RE: THE AMERICAN PUBLIC POWER ASSOCIATION’S COMMENTS ON THE ENVIRONMENTAL PROTECTION AGENCY’S PROPOSED FEDERAL IMPLEMENTATION PLAN ADDRESSING REGIONAL OZONE TRANSPORT FOR THE 2015 OZONE NATIONAL AMBIENT AIR QUALITY STANDARD; 87 Fed. Reg. 20,036 (April 6, 2022); Docket ID No. EPA-HQ-OAR-2021-0668

COMMENTS OF THE AMERICAN PUBLIC POWER ASSOCIATION
on the
FEDERAL IMPLEMENTATION PLAN ADDRESSING REGIONAL OZONE
TRANSPORT FOR THE 2015 OZONE NATIONAL AMBIENT AIR QUALITY
STANDARD; PROPOSED RULE
87 Fed. Reg. 20,036 (April 6, 2022); Docket ID No. EPA-HQ-OAR-2021-0668
June 21, 2022

Figure 7-7. Role of Days Following Startup on Days Exceeding Daily Rate

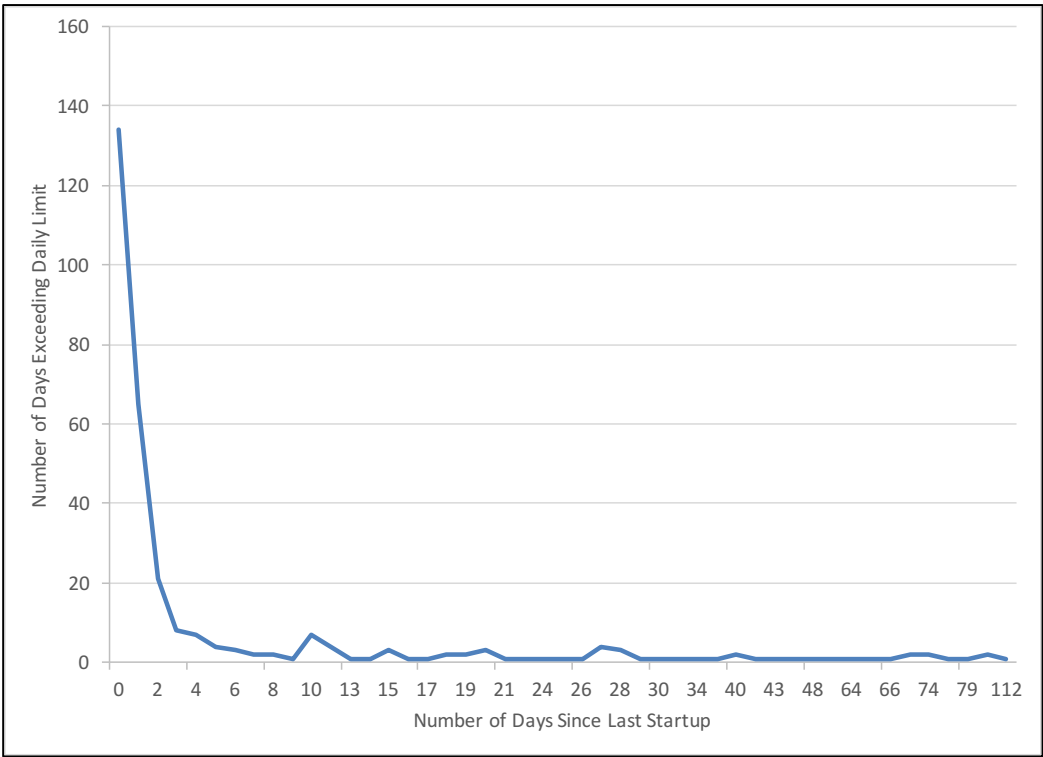
Figure 7-7 shows operating within 1 full day of startup, a total of 65 observed days were recorded with NO_x exceeding the 0.14 lbs/MBtu rate. But within a second day the observed days exceeding 0.15 was dropped by 1/3, to 21 total days. After 4 days such observations are negligible.

Figure 7-8. Role of Load Factor

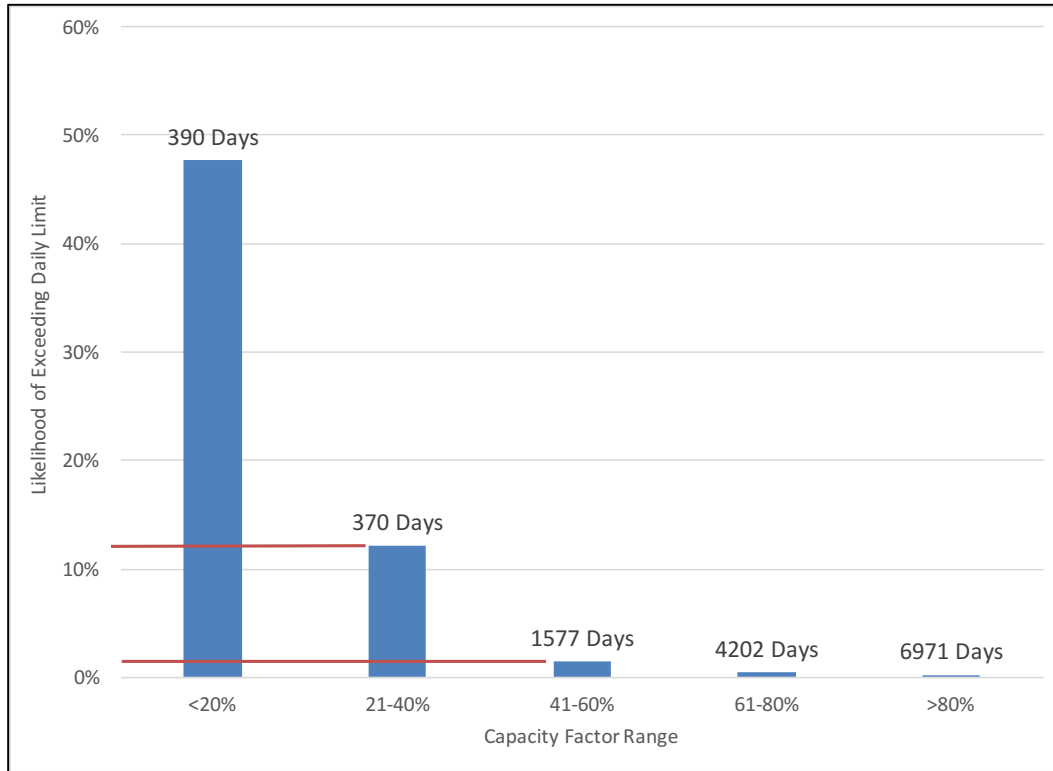
Figure 7-8 reports the cumulative number of days that all units in the 110-unit study population exceeded the proposed backstop rate of 0.14 lbs/MBtu for the 2021 ozone season. The left axis reflects the fraction of total operating days in each load “bin” that exceeded the proposed backstop rate. For example, over the 2021 ozone season, units operating at or below the 20% load “bin” recorded a total of 390 days exceeding the proposed backstop rate – equal to 47% of operating days in that load bin. A similar number of operating days – 370 – were recorded for all units operating in the 21-40% bin with NO_x exceeding the proposal backstop rate, comprising 12% of all operating days in that bin.

These data show units in the select boiler population which meets the 0.08 lbs/MBtu limit, it is almost unavoidable to incur an outage and thus startup that causes a unit to emit more than 0.14 lbs/MBtu. Even altering the definition of how the rate is calculated - from a daily rate to a short-term, multi-day rate such as an average of 2 or 3 days –leaves significant number of operating events exceeding the 0.14 lbs/MBtu rate.

Figure 8-4. Generation Shifting Summary: Kentucky

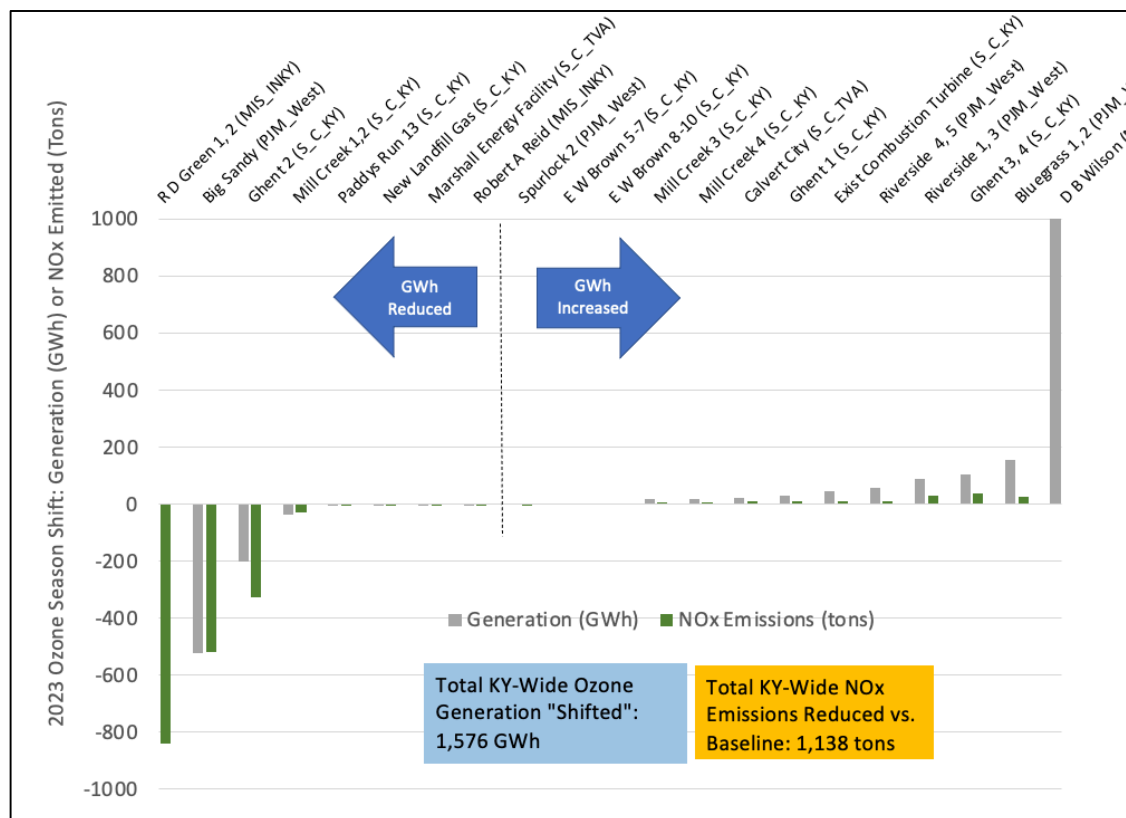
IPM idled 2.4 GW of Kentucky coal capacity in 2023, many of which had post-combustion controls. As a consequence of this idling, IPM idled both RD Green 1/2 (MISO) and Big Sandy (PJM), and brought on-line during the ozone season a low emitting coal unit – DB Wilson (MISO)- to offset generation, resulting in generation being shifted between two RTOs. The generation shift of 1,576 GWh results in a reduction of 1,138 tons of NOx.
